**HMC ARCHITECTS
3546 Concourses Street
Ontario, California 91764**

Arvin High School ESSER III Phase 1 Roofing

Kern High School District

File No: 15-H3 A#03-122508

BIM 360://3566002000 Arvin HS ESSER III 3566002000-A KHSD Arvin HS Roof Replacement.rvt
6/21/2024 4:02:35 PM

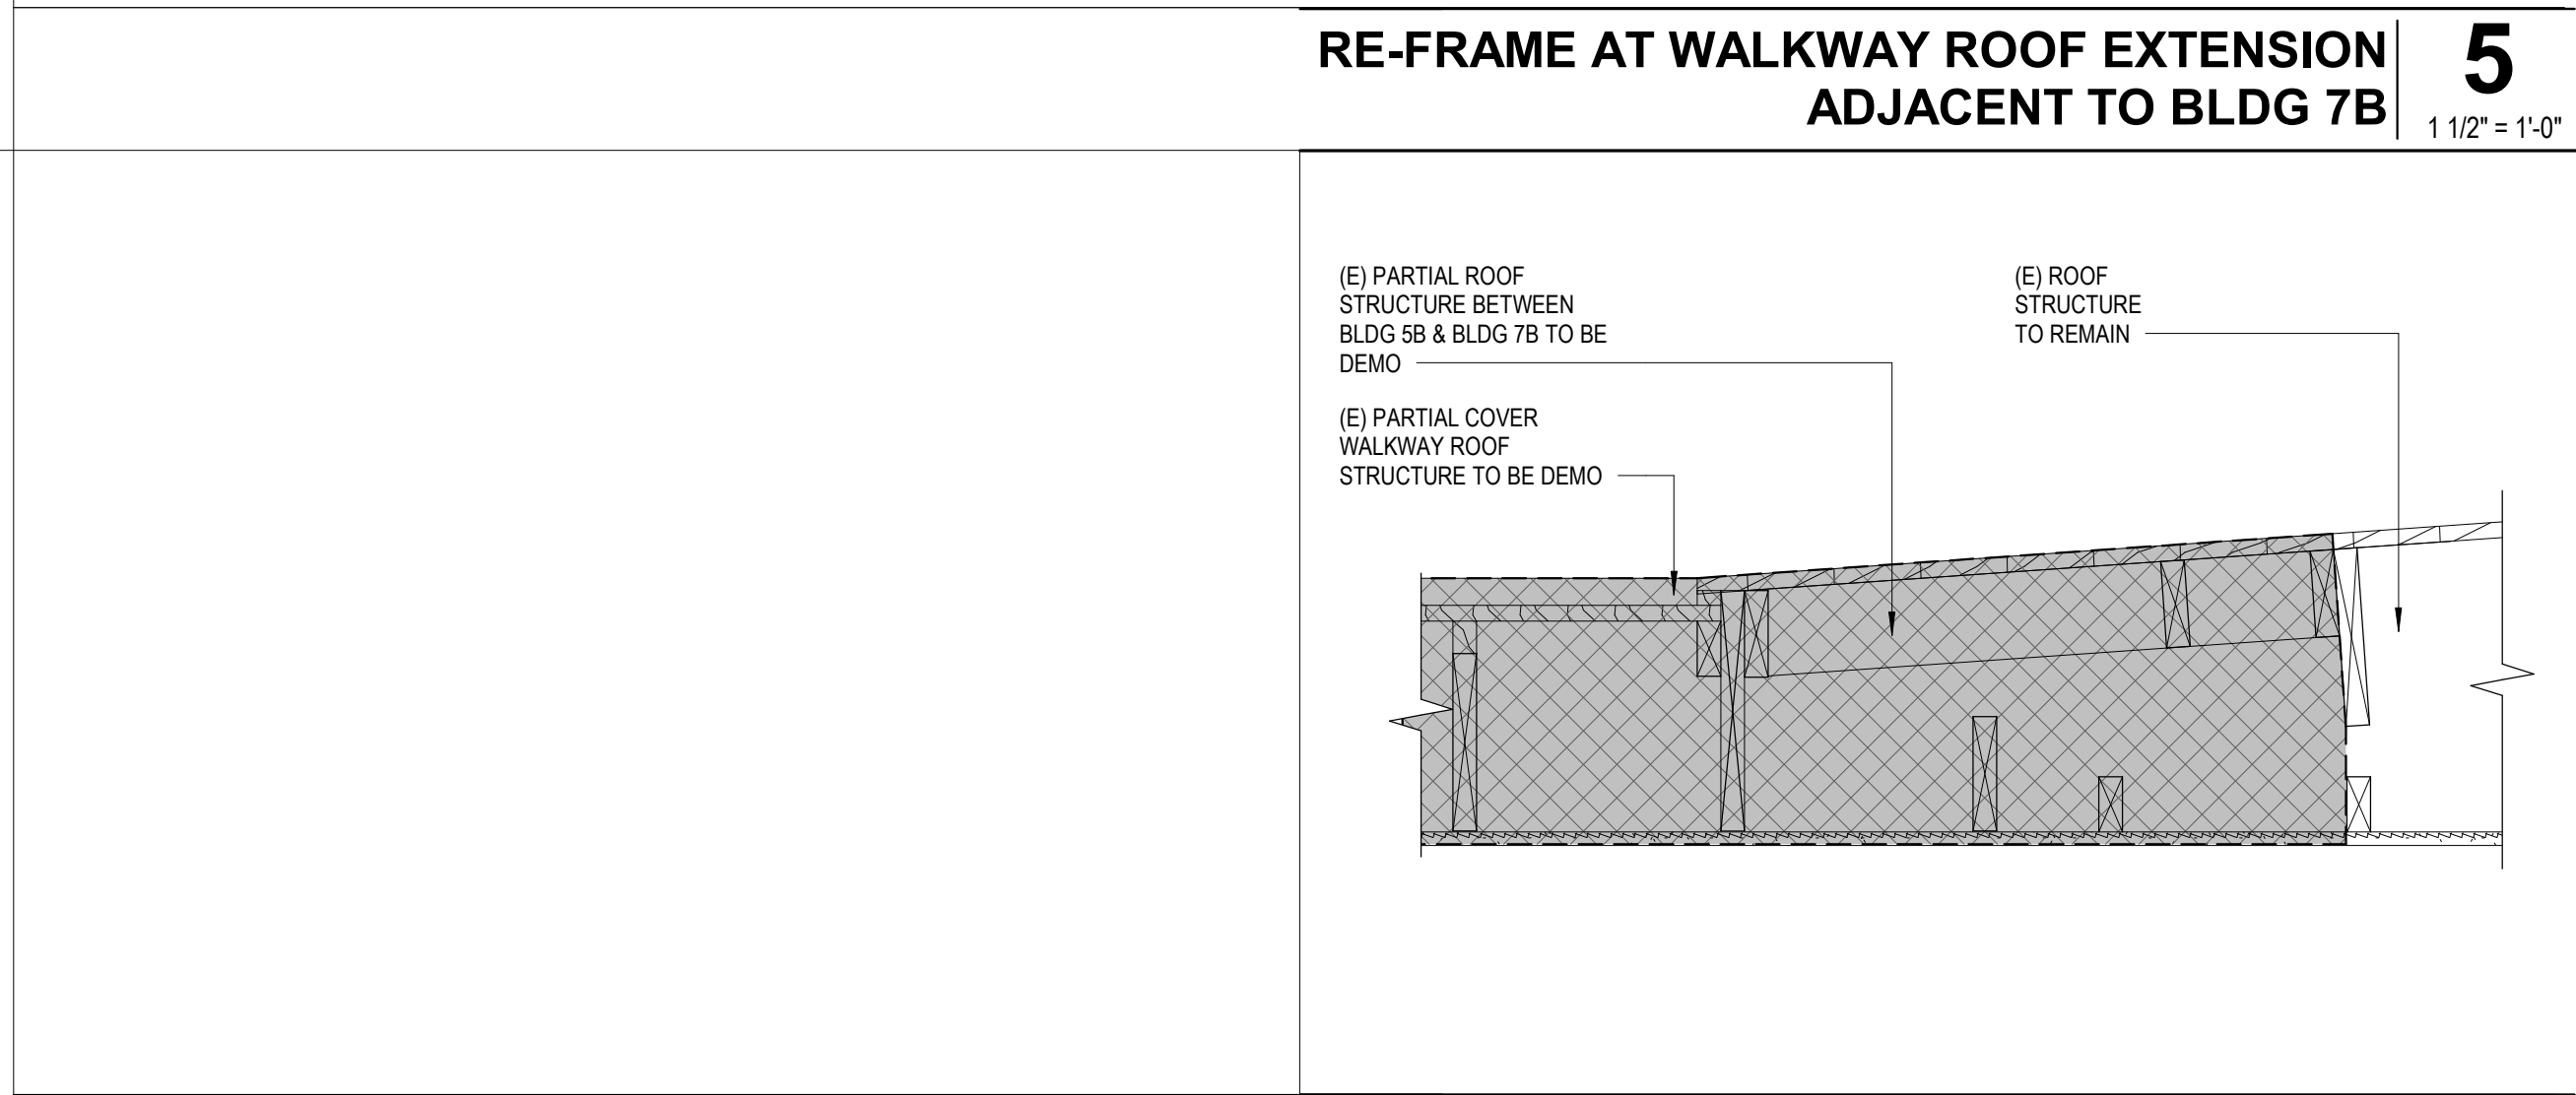
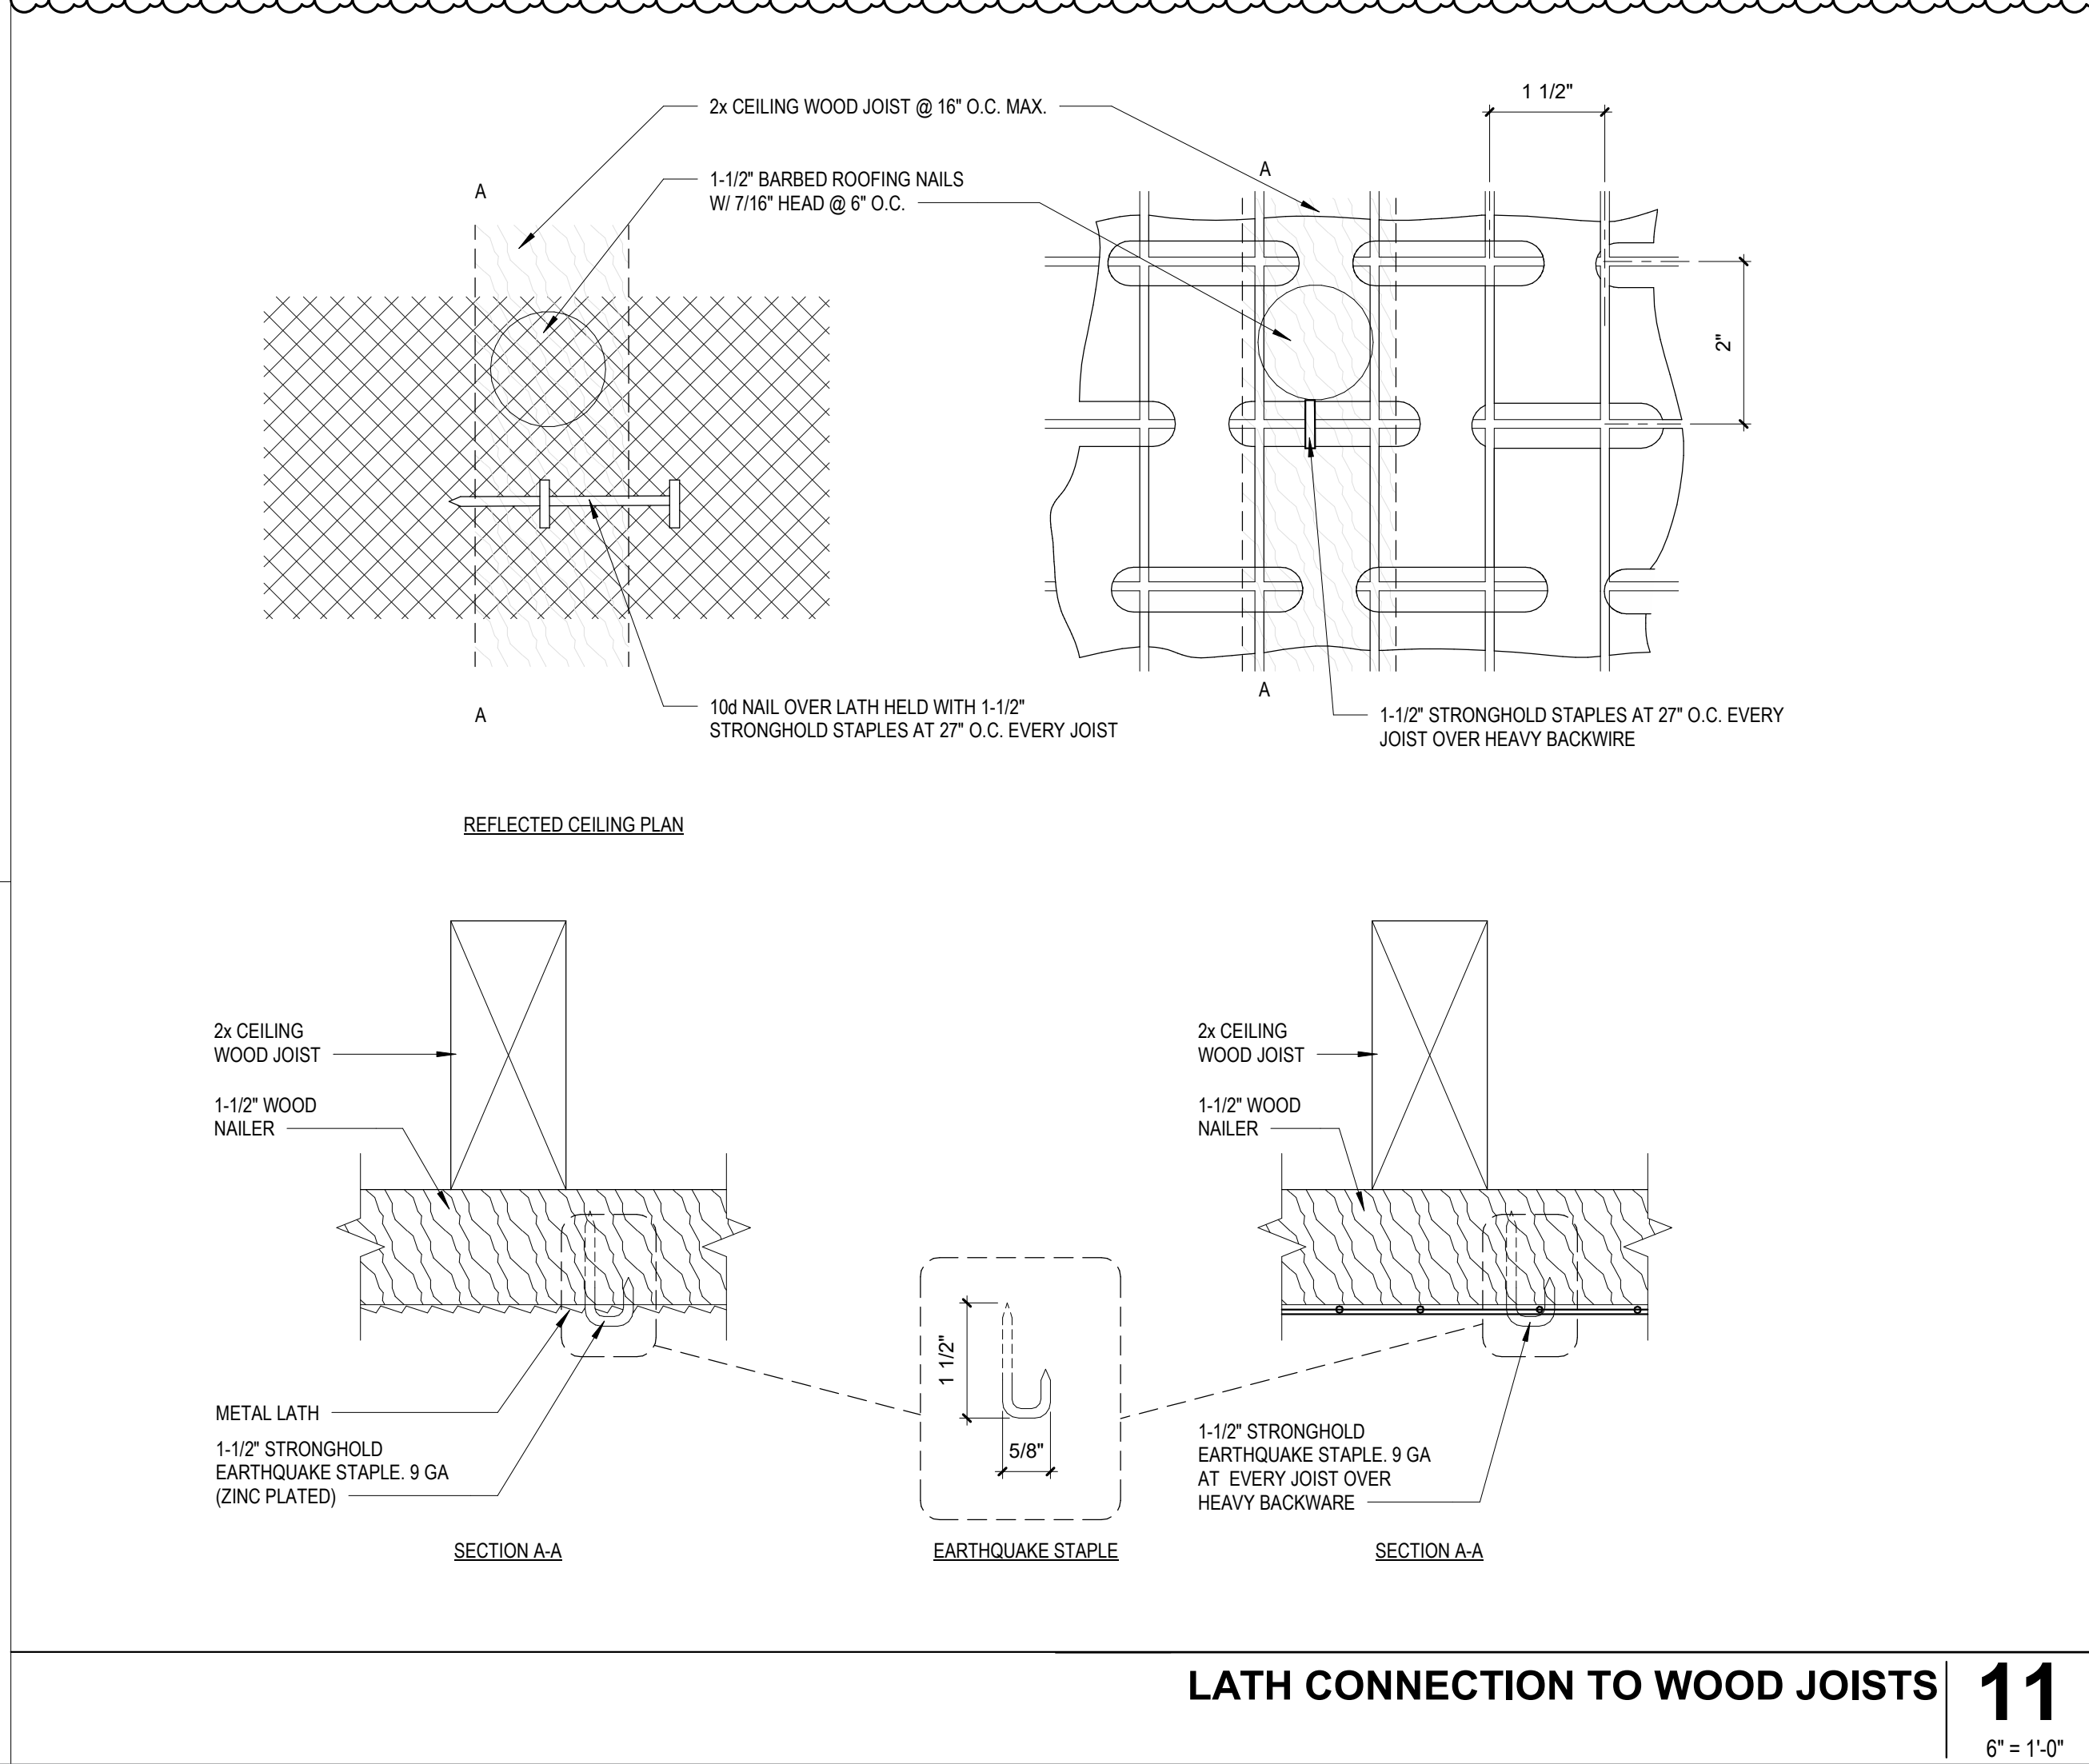
- A. **ADD** Details 8/A10.42 – Platform Edge and 12/10.42 – HVAC Mounting Detail to the Drawing Sheet as shown and clouded per Delta 3.
